Final Environmental Impact Statement

**REMEDIAL ACTIONS AT THE FORMER  
CLIMAX URANIUM COMPANY  
URANIUM MILL SITE  
GRAND JUNCTION, MESA COUNTY,  
COLORADO**

DECEMBER, 1986

FIGURE 3.1  
FINAL CONDITION - STABILIZATION ON SITE

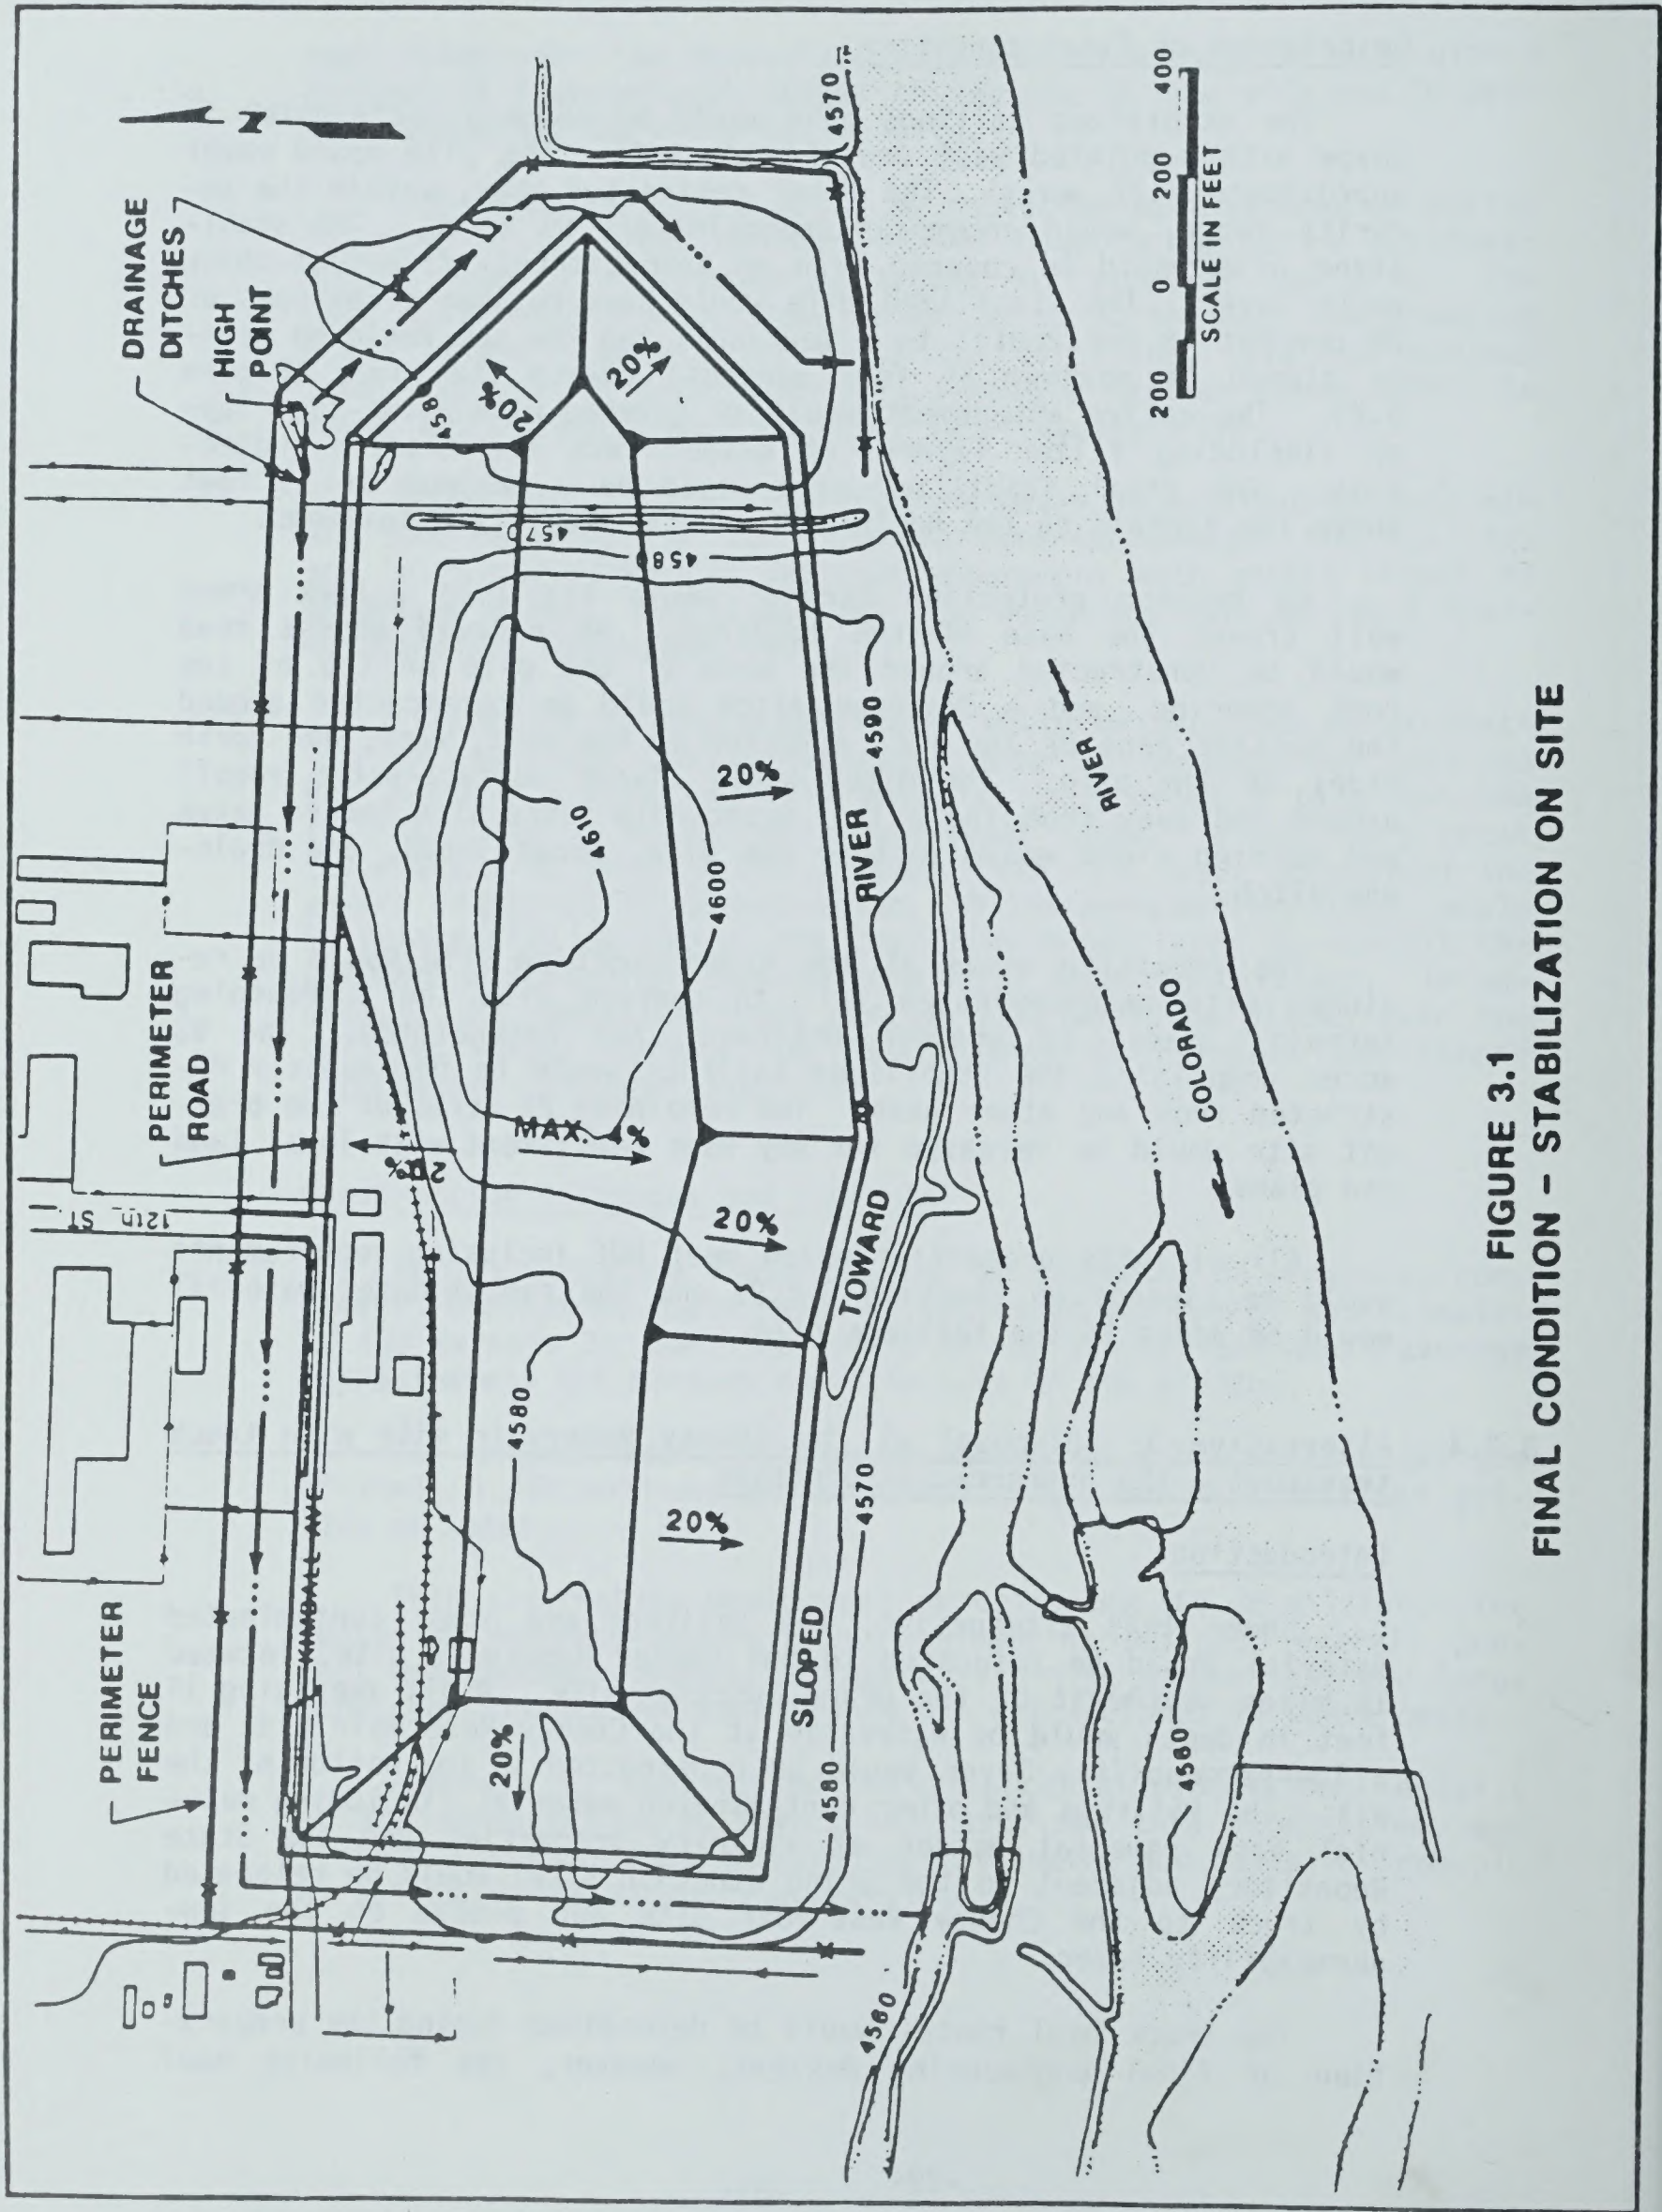
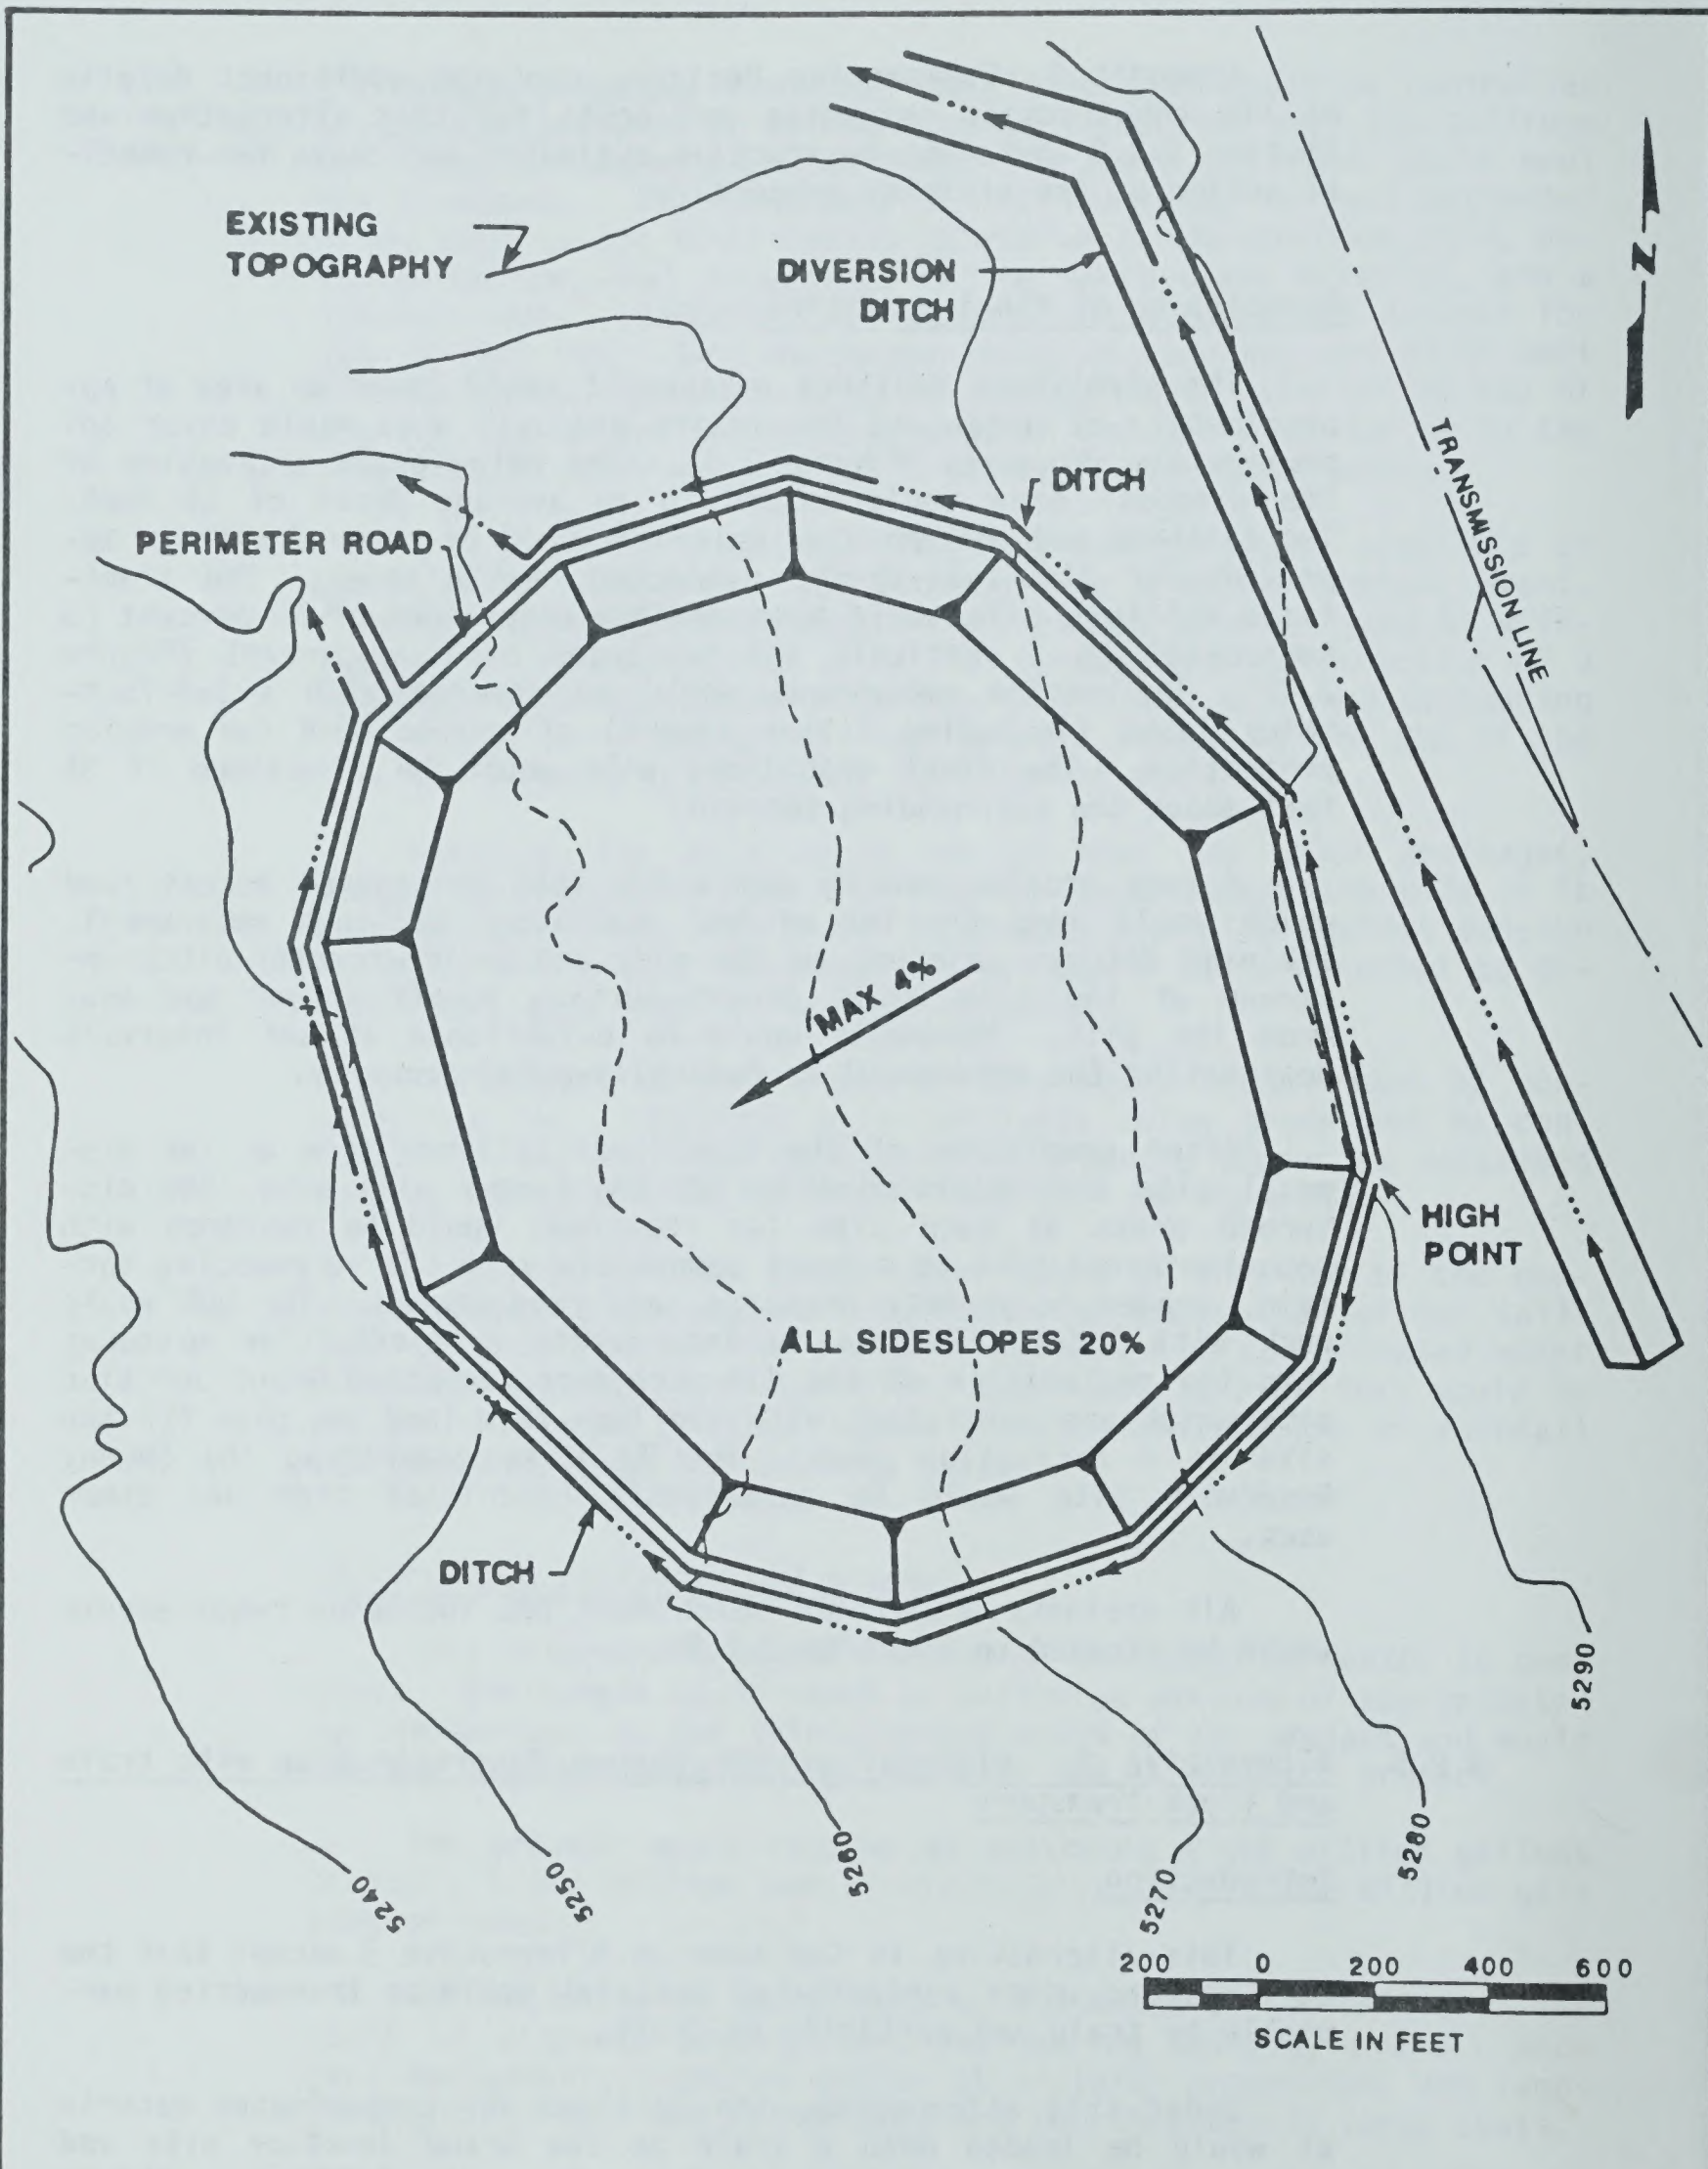
Since both the parent and relocation sites will be with us for centuries, the visual impact of the end result must be completely addressed and optimized. Unfortunately, your proposal (DEIS, Vol. 1, Fig. 3.1, 3.2, 3.3) are ugly and unimaginative - efficient but unaesthetic. When humans view these sites (and who can foresee how populations and their viewing angles will change over the decades) they must not be confronted with the tomblike monumental structures you propose - foreboding and depressing monstrosities guaranteed to shrink the soul. This would be a tragic and short-sighted result for such an enormous undertaking.

FIGURE 3.4  
TYPICAL CROSS-SECTION - CHENEY RESERVOIR ALTERNATE DISPOSAL SITE

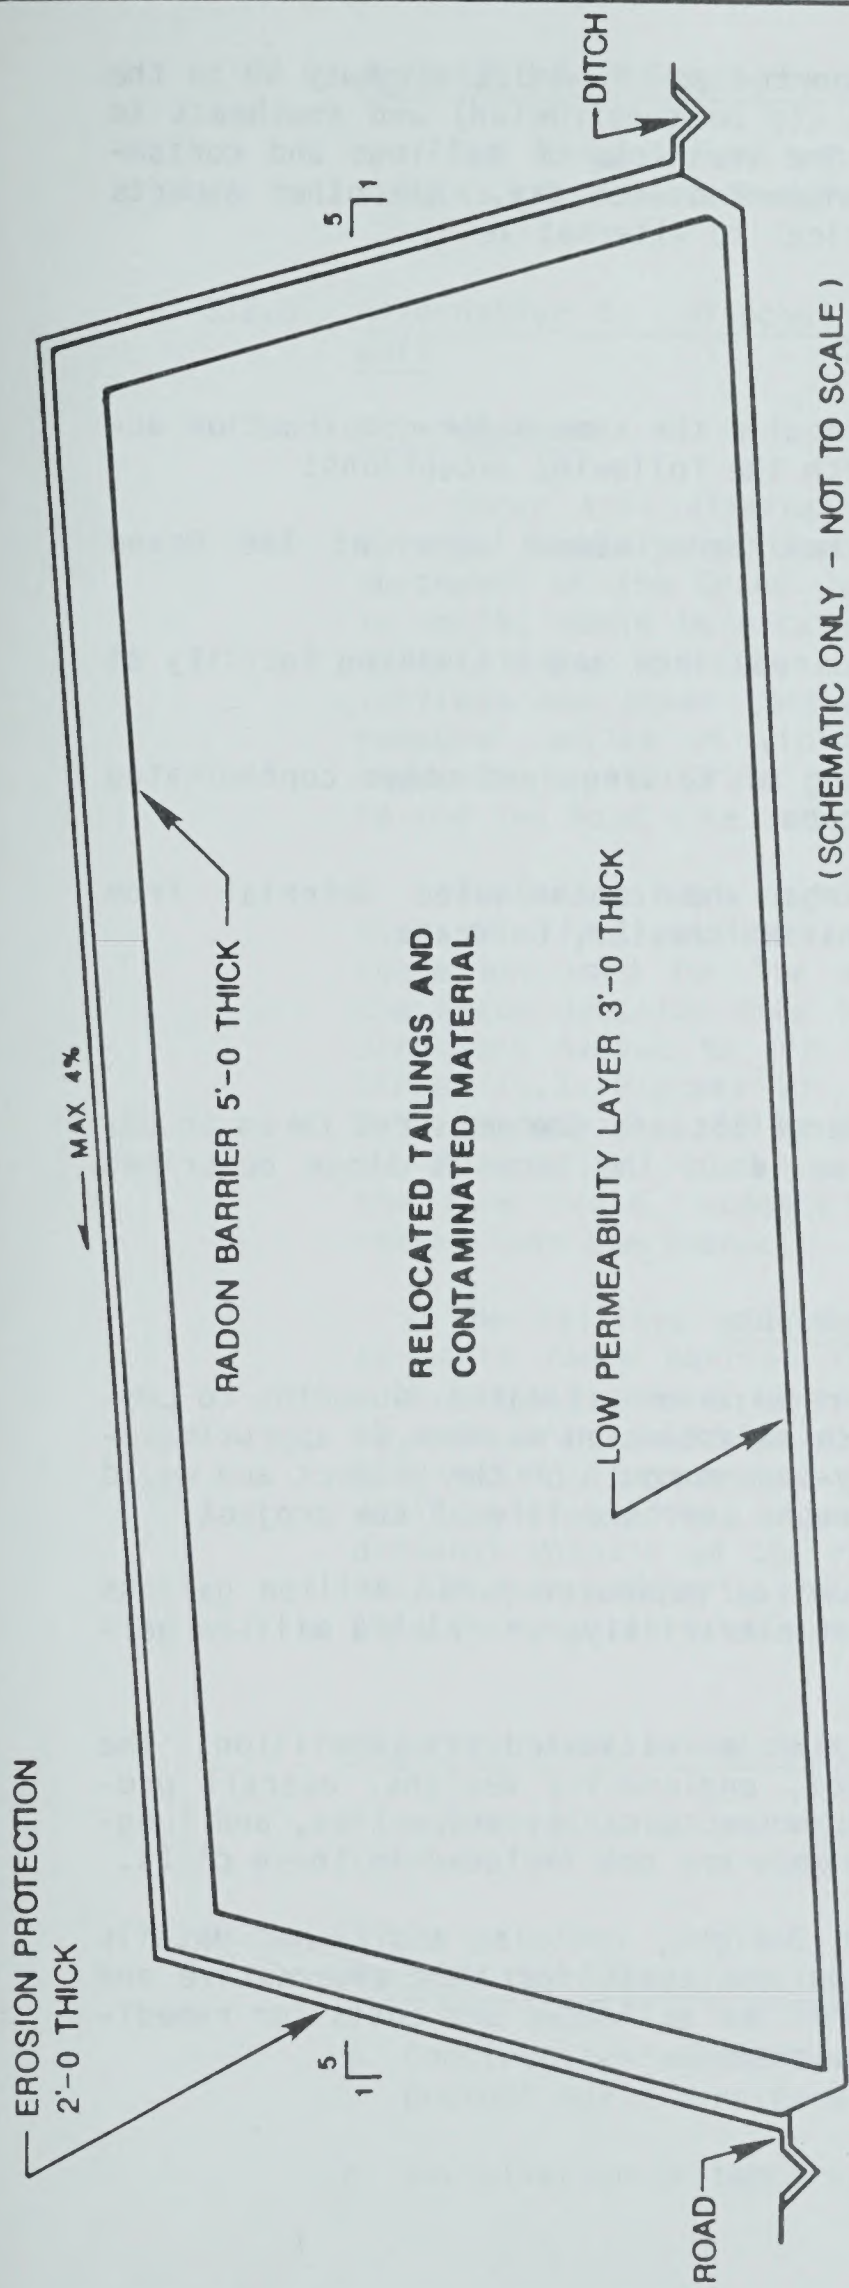
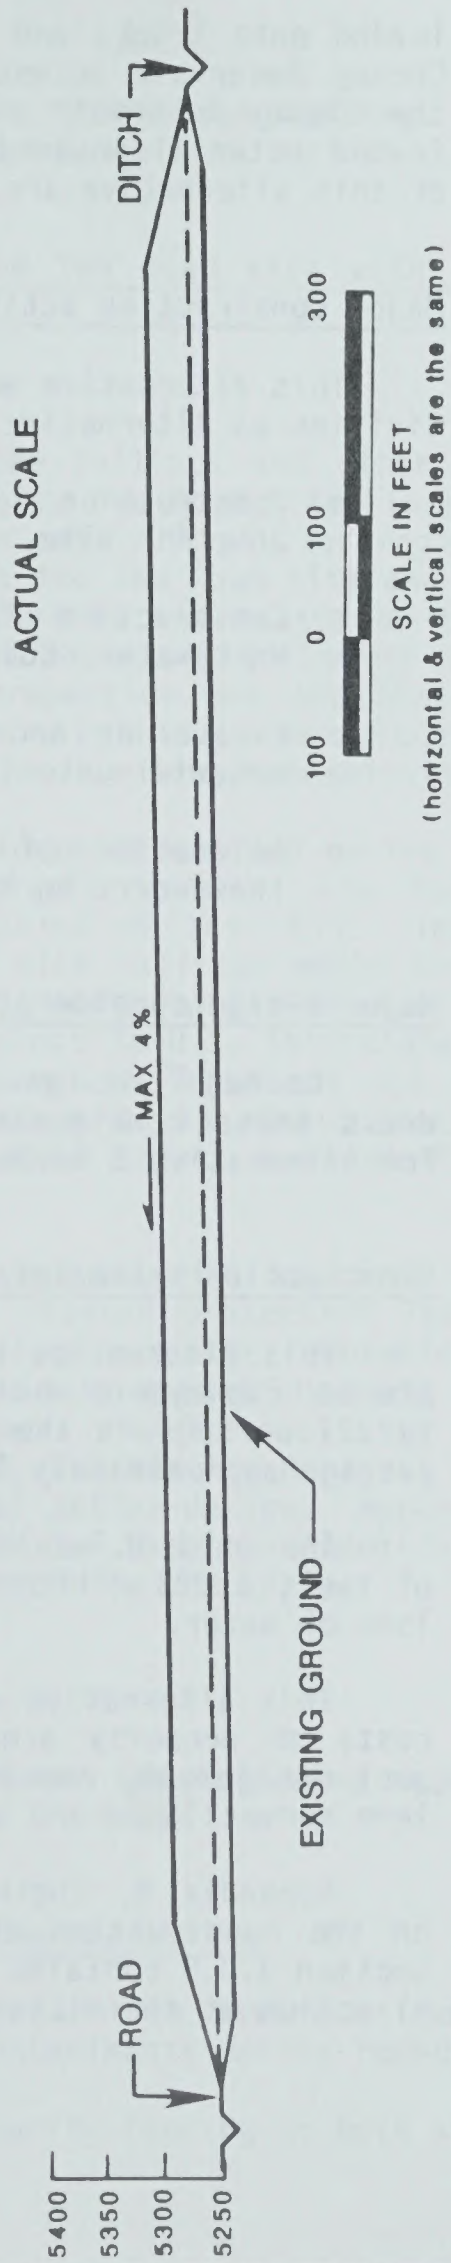
- 29 35 Figure 3.4 6.4.25 Two feet of rock on top of 5'0" of compacted soil cover does not appear to offer sufficient protection of the radon barrier and the tailings (i.e. provide for long-term stability). See comment #28.
